CONSTRUCTION DOCUMENTS

FALCON MARKETPLACE

SF-19-001

75% SUBMITTAL 12-20-18

POND #3 & DETAILS

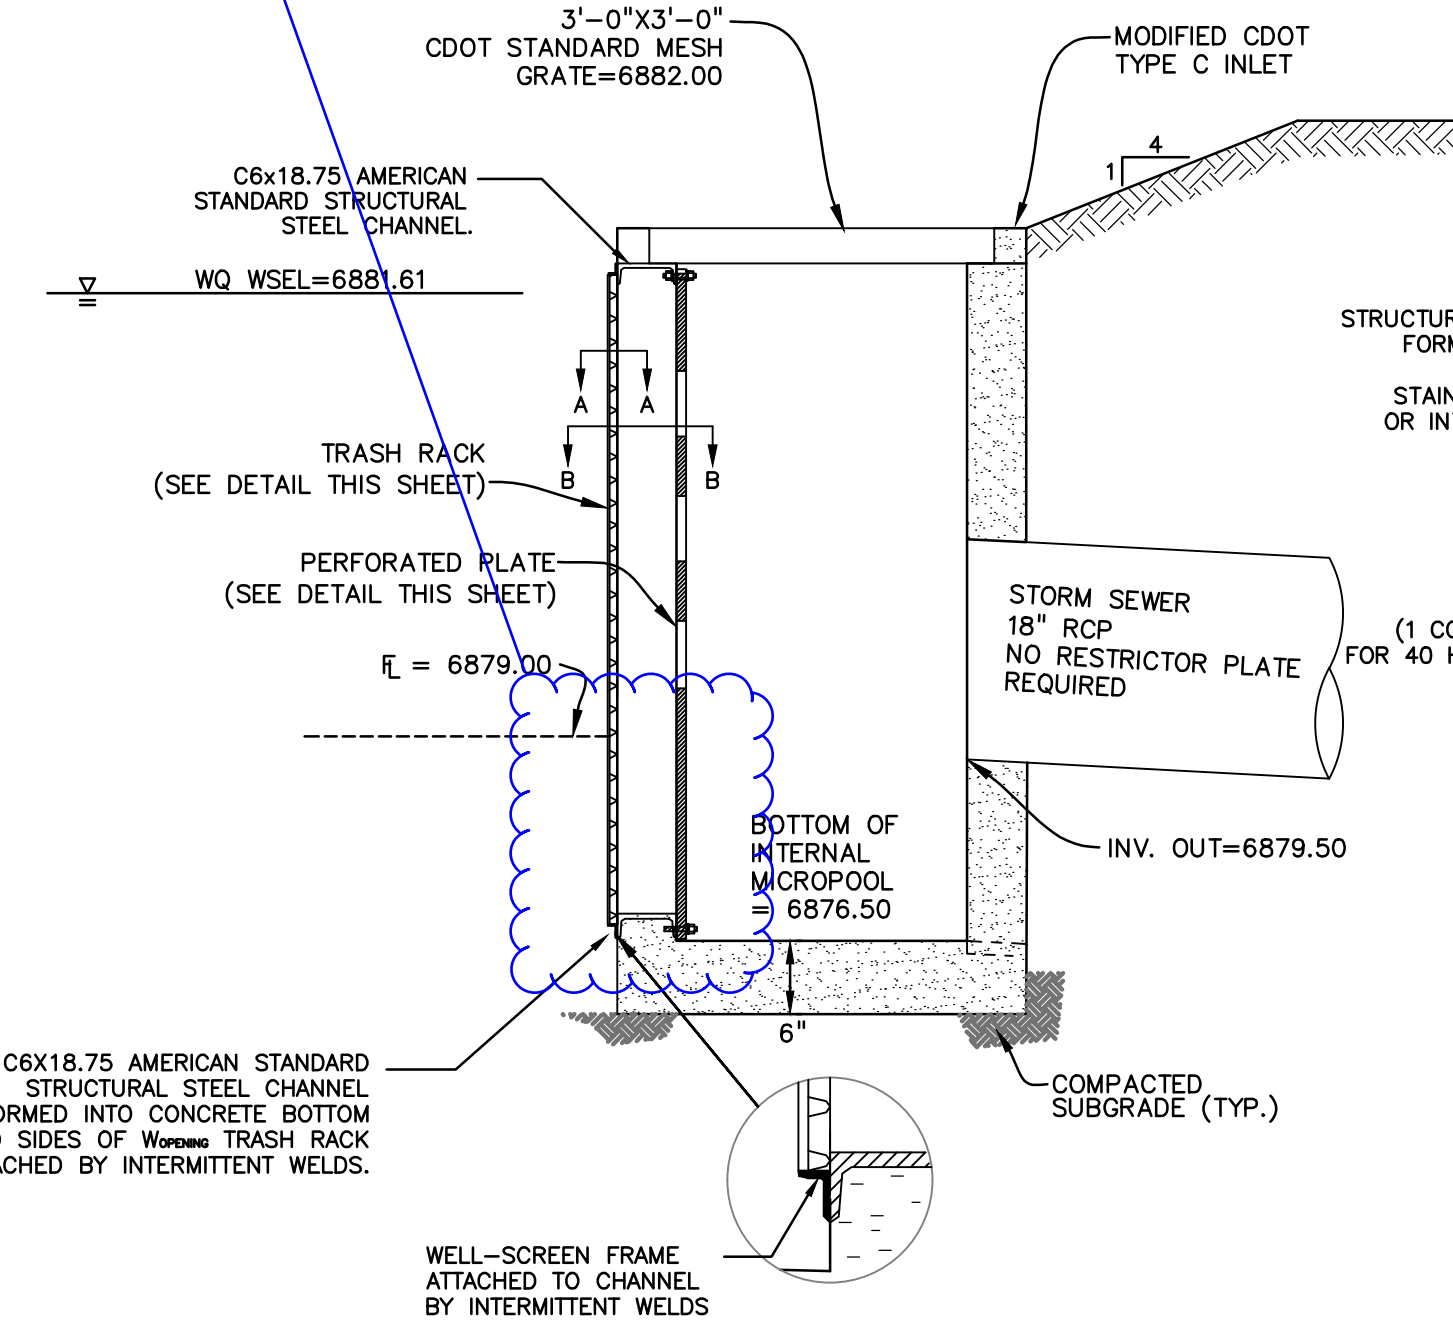
This doesn't make sense. Split the inlet or provide a micropool before the well screen. Reference UDFCD Volume 3, T-12 page OS-11.

Provide details and cross-sections

provide detail

Provide
